RE: Addendum No. **Two (2)** to the Bidding Documents for:  
**NEW Crosby Vehicle Storage Garage, South Portland, ME**

## MTA Crosby\_Addenda Questions - Contract 2021.06 ADDENDUM 2

CONTRACT 2021.06  
 CROSBY VEHICLE STORAGE GARAGE  
 DETAILS - 1

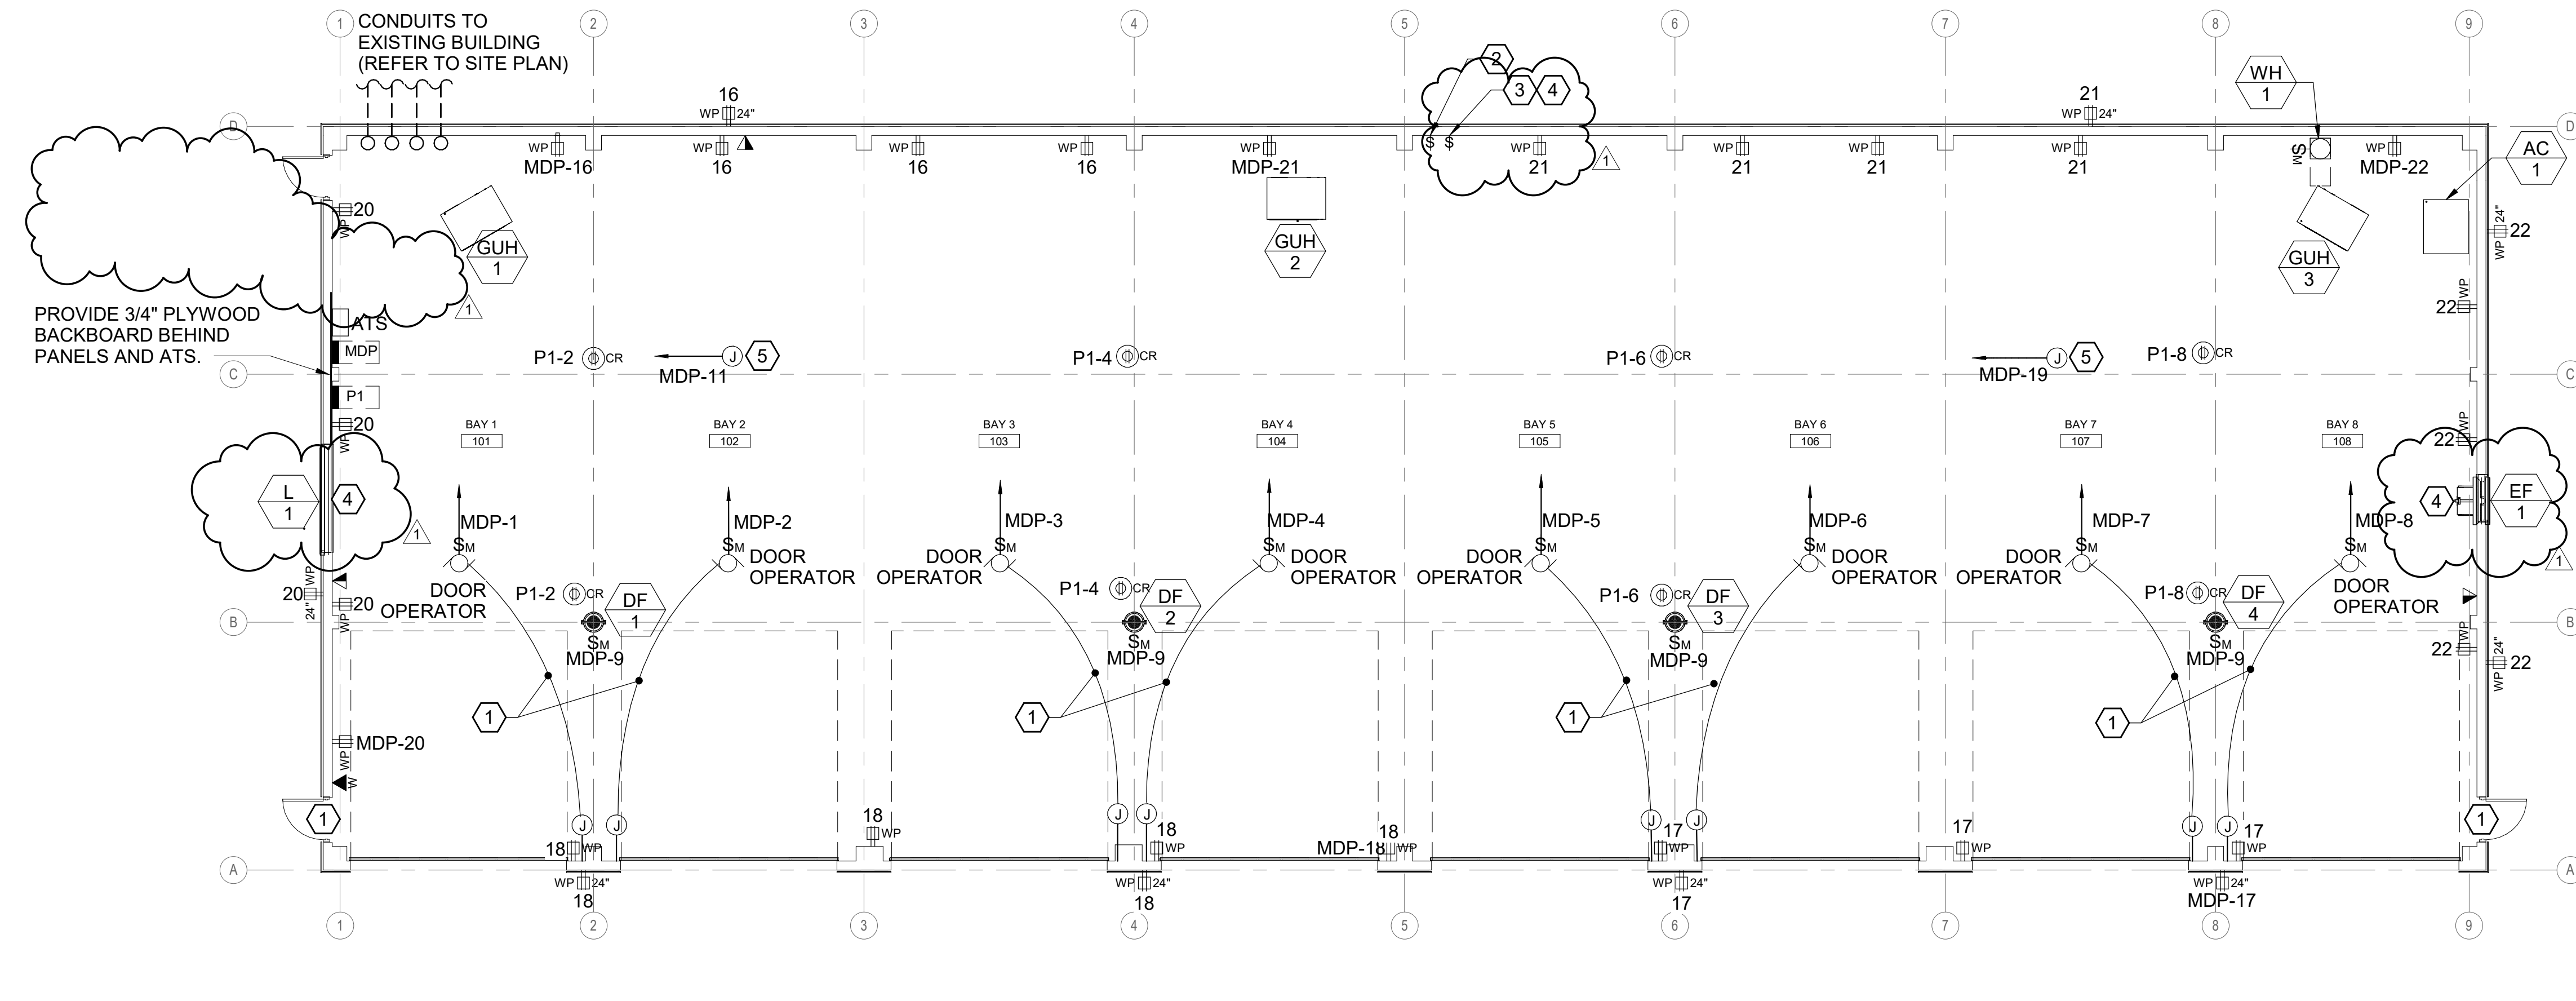
17-Dec-21					
Crosby Vehicle Storage Building					
Contractor/Vendor	Sheet	Plan/Spec	Question	AEI Team Response/Resolution	
1		ES100, EP500, & C401	C401 identifies the primary conduit to be (2) 5", the feeder schedule on E500 identifies the conduit to be a single 4", Please clarify.	<b>G.P:</b> C-401 revised to reflect and match ES100 and ES500. <b>AEI:</b> These 2 schedules are not referring to the same thing. The feeder schedule on the electrical drawings is referring to the feeder from the transformer to the building. The service is overhead so there are no 5" utility conduits for power company wiring. These shall be removed from the civil drawing by addenda	
2	Mancini Electric		C401 identifies two 4" conduits for phone and data, They are not identified within the electrical plans, will the conduits be required?	<b>G.P:</b> C-401 revised to reflect and match ES100 and ES500. <b>AEI:</b> The owner has decided to delete tel com service to the building. The conduits have been deleted by on C-401 this addenda as well as interior tel/data outlets and backboard on .

- KEYED NOTES:**
- 1 PROVIDE EMPTY J-BOX 44" ABOVE FINISHED FLOOR AND 1-1/2" EMPTY CONDUIT FOR DOOR CONTROL WIRING AND CONTROLS BY OTHERS.
  - 2 DESTRATIFICATION FAN DF-1 thru DF-4 MANUAL SPEED CONTROL CONTROLS BY OTHERS.
  - 3 EXHAUST FAN EF-1/L-1 VENTILATION TIMER AND VARIABLE SPEED CONTROL LOCATIONS - CONTROL DEVICES SUPPLIED BY DIVISION 23, WIRED BY DIVISION 26.
  - 4 WIRE AND CONNECT L-1/EF-1 THROUGH TIMER SWITCH AND VARIABLE SPEED CONTROLLER SUPPLIED BY DIVISION 23. COORDINATE WITH DIVISION 23.
  - 5 PROVIDE 120-VOLT POWER FOR HVAC CONTROLS AT UNDERSIDE OF DECK. CONTROLS BY OTHERS.
